**COUNTY OF ALBEMARLE
PLANNING STAFF REPORT SUMMARY**

Project Name: ZMA202300004 Cornerstone Community Church	Staff: Rebecca Ragsdale, Planning Manager
Planning Commission Public Hearing: November 14, 2023	Board of Supervisors Public Hearing: To be scheduled
Owner: Peggy W. Dettor/James A. Dettor	Applicant: Line+Grade, Kendra Moon and Daniel Heyer, representing Cornerstone Community Church
Acreage: 3.578 Acres	Rezone from: R1 to C1 Commercial
TMPs: 07800-00-00-058K0	Location: 1395 Stony Point Road
School Districts: Monticello High, Burley Middle, Stone-Robinson Elementary	By-right use: 1 dwelling unit/acre
Magisterial Districts: Rivanna	Proffers: Yes
Proposal: 300-seat religious assembly use and up to 13,500 square feet of commercial uses. The request also includes a special exception (SE202300031) to reduce the 50-foot setback to a residential property line.	Requested # of Dwelling Units: No additional dwelling units are requested.
DA (Development Area) – In Neighborhood 3, in the Pantops Master Plan area.	Comp. Plan Designation: Urban Density Residential – residential (6-34 dwelling units/acre), religious assembly uses, schools and child-care, institutional. Secondary commercial

Image 5 – Sketch of existing versus proposed FEMA floodplain limits

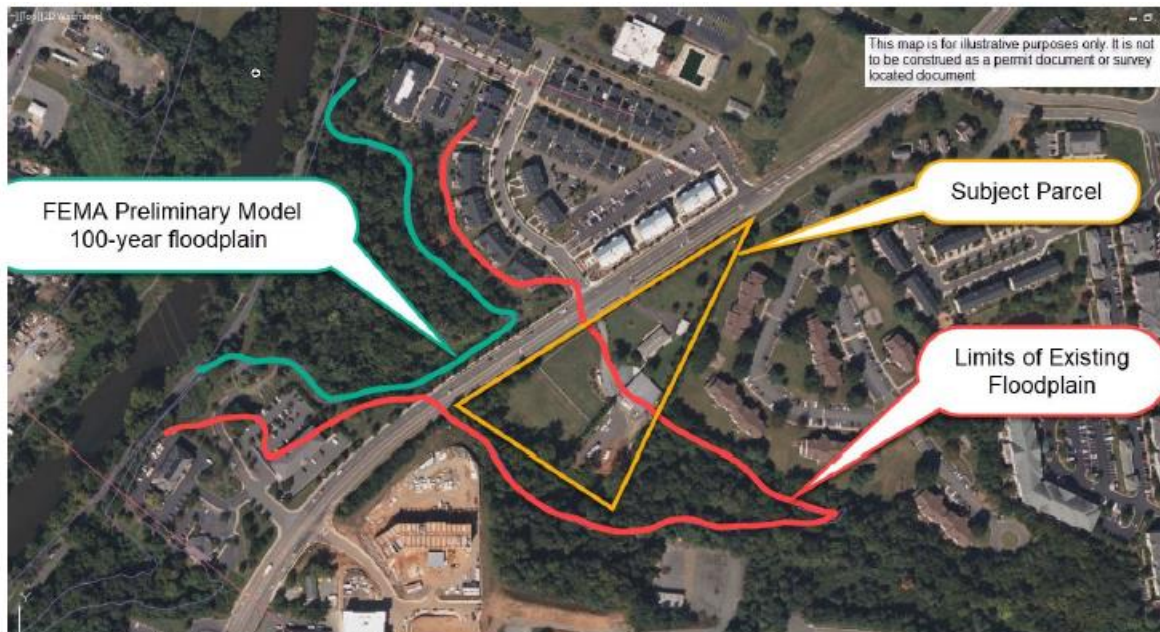
The property is located in the Flood Hazard Overlay district according to the current applicable FEMA map and there is a perennial stream that runs along the southern boundary of the property.

Existing parking and a small portion of the garage building are located within the floodplain according to current FEMA boundaries. The draft FEMA maps available no longer show the property in the floodplain. A required 100-foot stream buffer from the top of the perennial stream bank remains. The applicant's concept plan has been developed according to FEMA map changes expected in 2024. The concept plan proposes to remove all parking located in the stream buffer and mitigation plantings are proffered. Staff believes this addresses impacts to the stream buffer that have occurred. Should the FEMA maps not be amended as expected, staff does not recommend parking remain in the flood plain even though the ordinance allows parking in the flood plain as long as it is not overnight.
